PRODUCT UPDATE

#221

New Crimp Contact Retention Force Test Tools

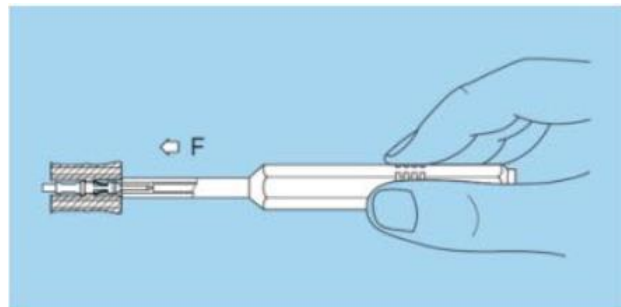
The tools used to test the crimp contact clip retention for contact diameters 0.5mm through 1.3mm have been updated to reduce the force necessary to effectively verify proper seating. Test force values have been reduced up to 60%, depending on contact size. If you have the previous version tools you can continue to use them however moving forward only the new reduced force versions will be available for purchase.

New part numbers have been created to reflect the lower forces per the charts below:

Ø A Contact	Test Force (N)	Retention test tools reference		Test Force (N)	Previous retention test tools reference	
		For Male contacts	For Female contacts		For Male contacts	For Female contacts
0.5	4	DCK.91.050.4LRC	DCK.91.050.4LRM	8	DCK.91.050.8LRC	DCK.91.050.8LRM
0.7	6	DCK.91.070.6LRC	DCK.91.070.6LRM	10	DCK.91.071.0LRC	DCK.91.071.0LRM
0.9	8	DCK.91.090.8LRC	DCK.91.090.8LRM	14	DCK.91.091.4LRC	DCK.91.091.4LRM
1.3	10	DCK.91.131.0LRC	DCK.91.131.0LRM	25	DCK.91.132.5LRC	DCK.91.132.5LRM
